# DeKalb County Historic Preservation Commission

## Staff Report

- L. 1201 Springdale Road, Warner McConaughey. Demolish greenhouses, construct a new garage, modify driveway, install wooden fencing, and construct a back deck. **1246967**

# EDUPUGANTI RESIDENCE

PROJECT DATA & PROPOSED SITE PLAN

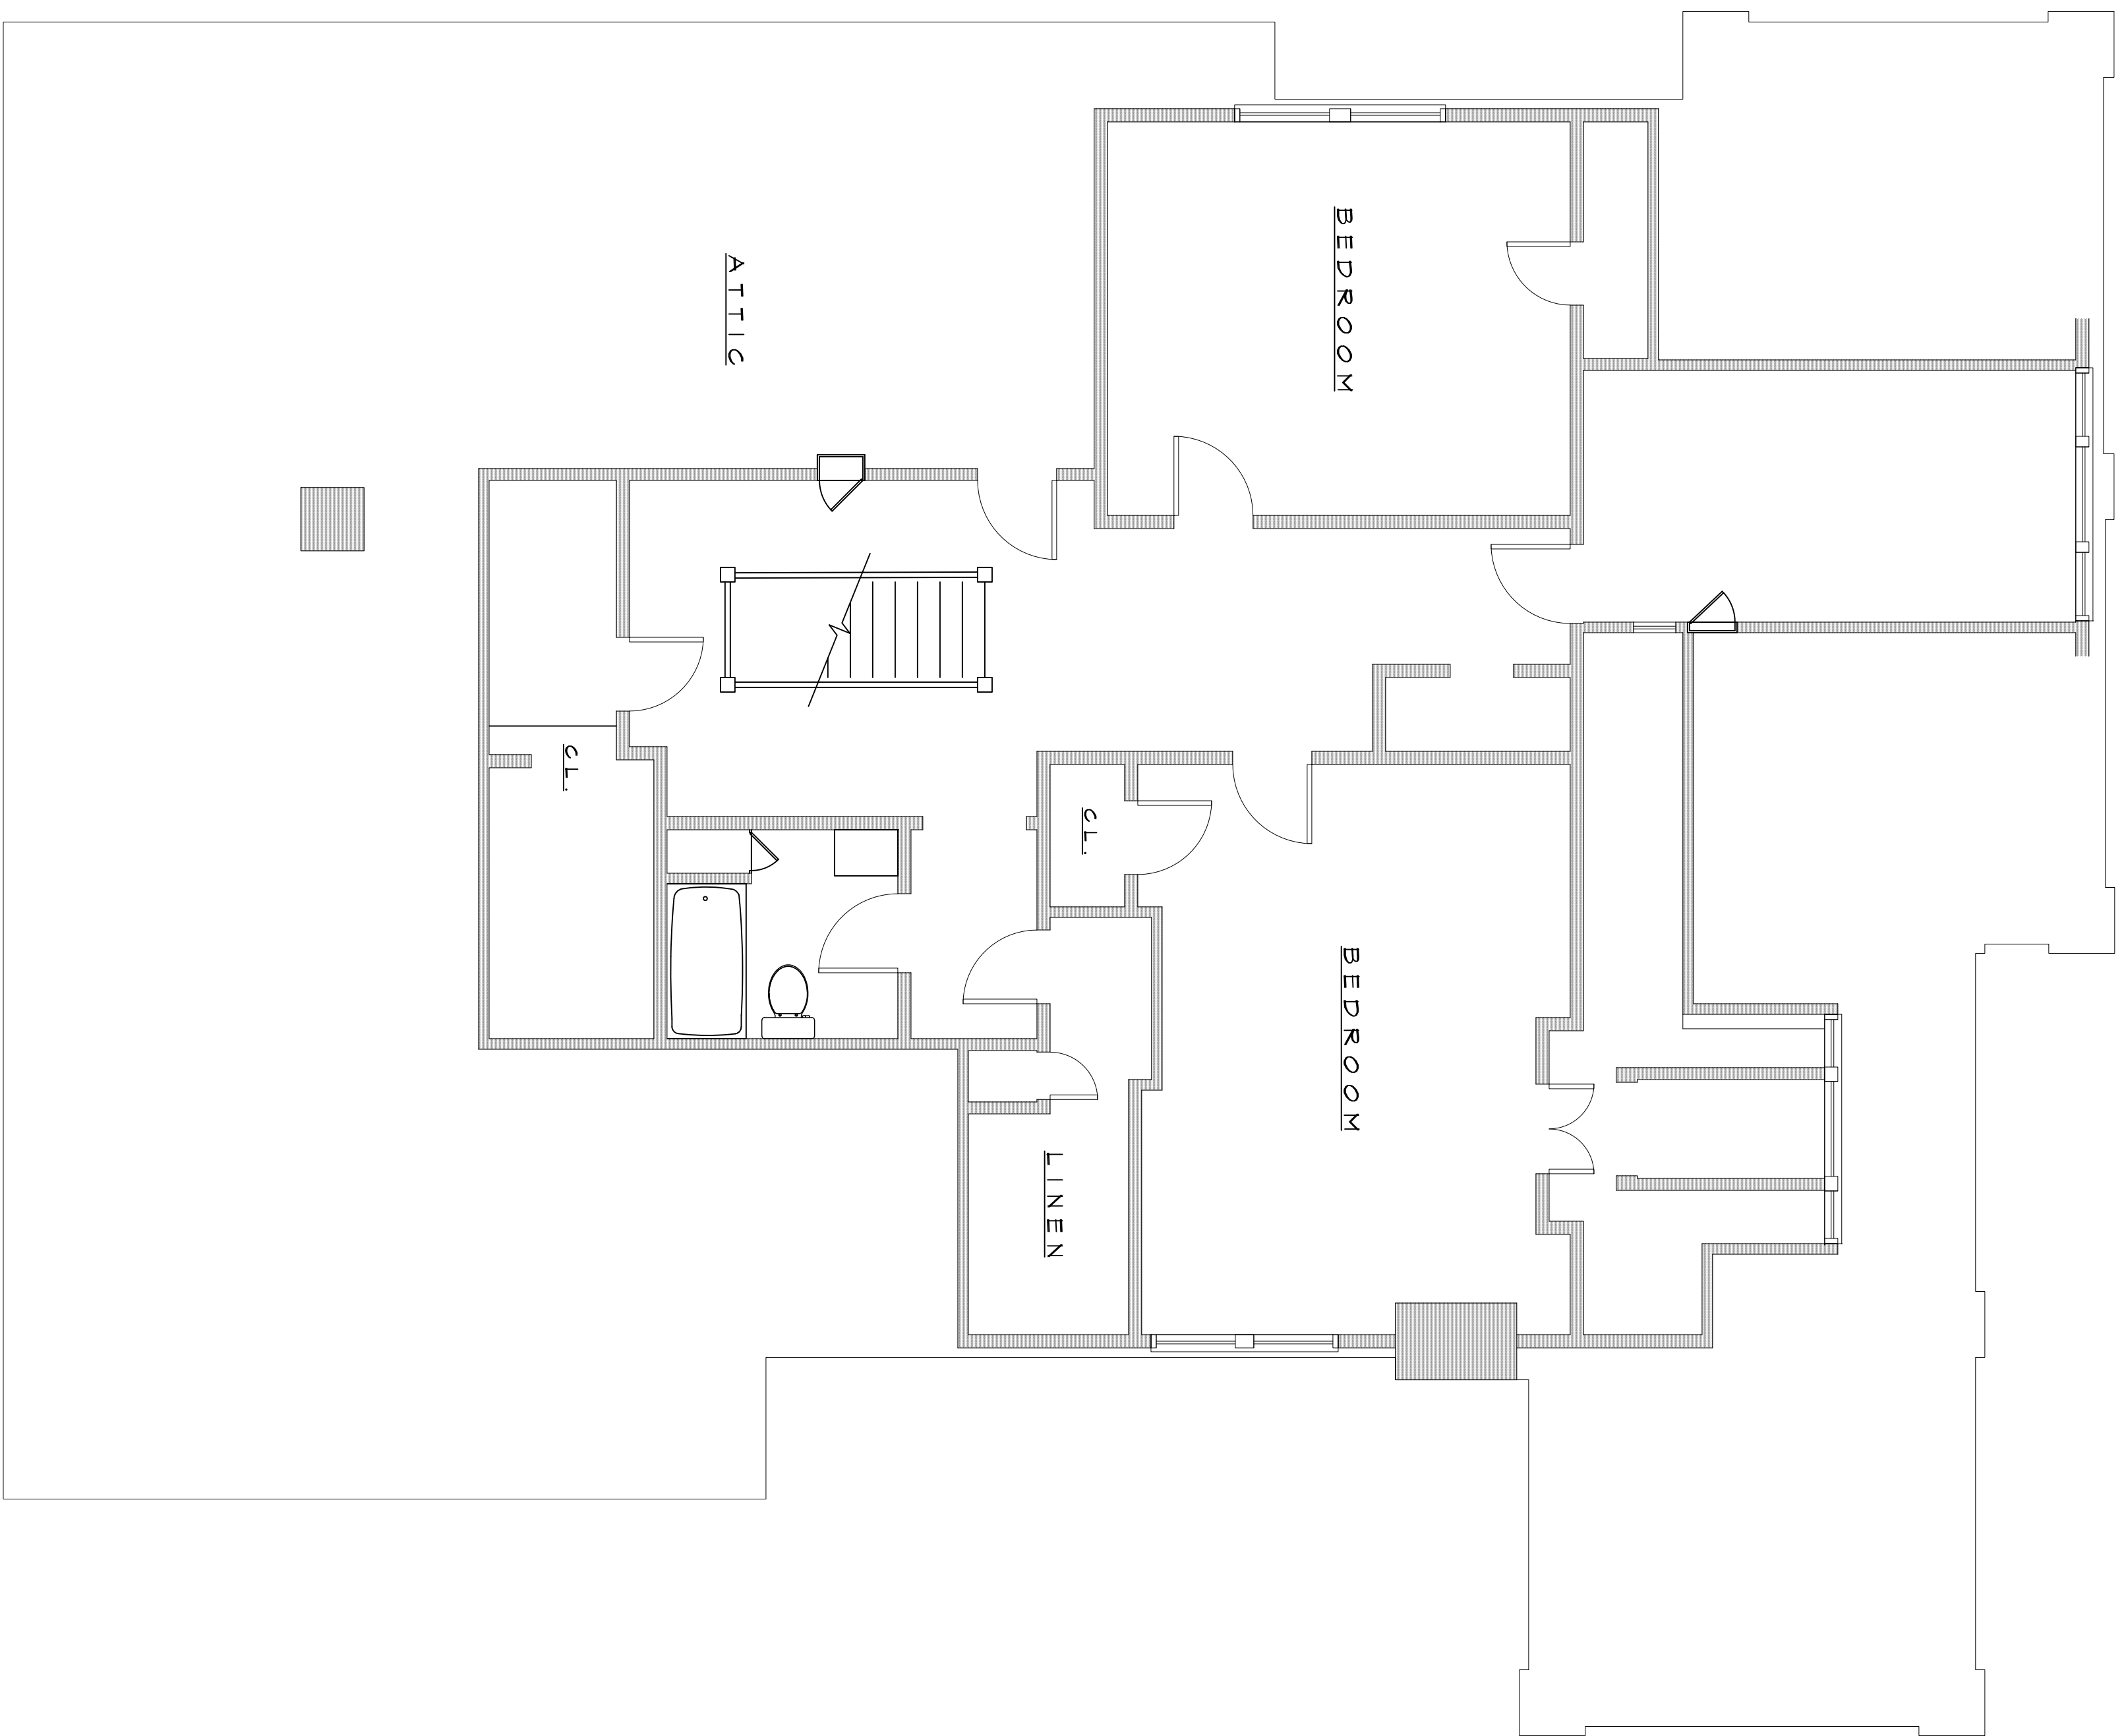
1- How much will the driveway be widened to create the new parking apron? What is the final size of the parking apron?

5- The metal fencing is listed as 4' in the architectural detail and 5' in the site plans; what is the proposed height for the metal fence? **All would be 48" tall.**

**The existing driveway in front of the porte-cochere will remain unchanged, except for repair of the existing entrance at street. The existing concrete parking apron at the rear of the porte-cochere will be removed and replaced with a new parking apron. New concrete parking apron will begin approx. 11'-6" closer to the street than the existing. New parking apron will be approx. 34'-9" wide x 24'-0" deep. Existing concrete apron removed = 1050 sf. ; new concrete apron = 1027 sf**
